Sea Street Bathhouse and Keyes Memorial Beach

ADA Transition Plan

September 2021

Institute for Human Centered Design

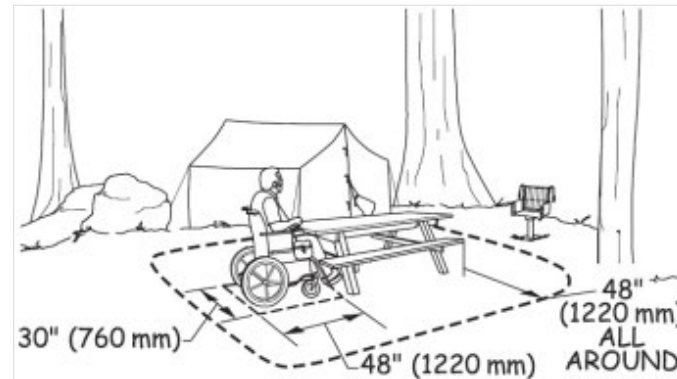
Note: The picnic area has newer picnic tables but they lack the required 19" knee clearance. See fig. below.
